## MESA COUNTY APPLICATION FOR A PLANNING CLEARANCE

Re: 201 North Ave.

To: Jim Shanks From: Kail Metzner Re: Proposed site plan at 201 N. Hve Mr. Coukes letter of 4/11/89. The site plan looks acceptable except for the following Oddon't understand the proposal for the Two 12' concrete pads on each side of The landscaped area. If these pads were deleted and added to the landscaped area Mr. Coake could fully satisfy his landscape requirements. requirements. 1 2) The dotted line shown as a settinck from 2nd street is not a sextack but the property line. 3 Since both the landscaping and the sidewalk would be within the Jud street right-of-way, dry could not be affected by any future construction on the site. Here improvements now, @ We discourage the use of planters for landscaping. If planters are used the square footage of each planter should be calculated to arrive at the Total landscape requirement. 5) Mr. Coeshe's letter states that Thre was no landscaping previously in the site. This is incorrect. There were a number of street trees along the second street frontage These were ceit down when the motel was demoleshed.

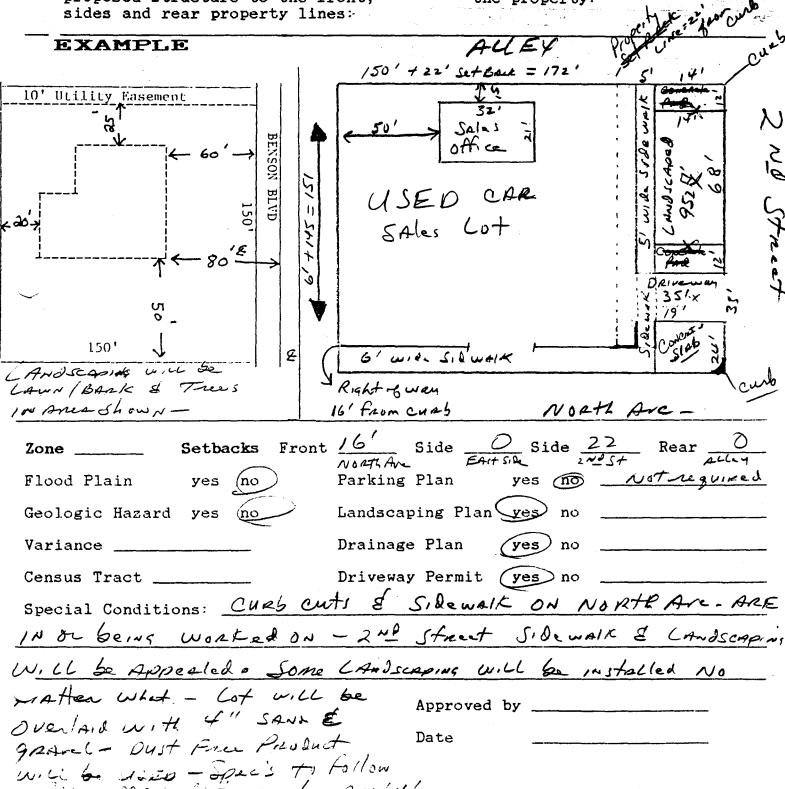
O Normally a specific land soupe plan as described in section 5-6-6 of the zoning and development code is required. month sue property line is shown as Cur records show that from the out

I have reviewed your request for a Planning Clearance for the proposed used car lot at 201 North Ave. The issuance of the planning clearance includes the construction of the sidewalk on 2nd Street and North Ave., installation of landscaping as shown on the plan, the application of a dust-free material to the parking The landscaping as shown on the plan is approved with the stipulation that at least 3 trees and 3 shrubs be planted in the landscaped area.
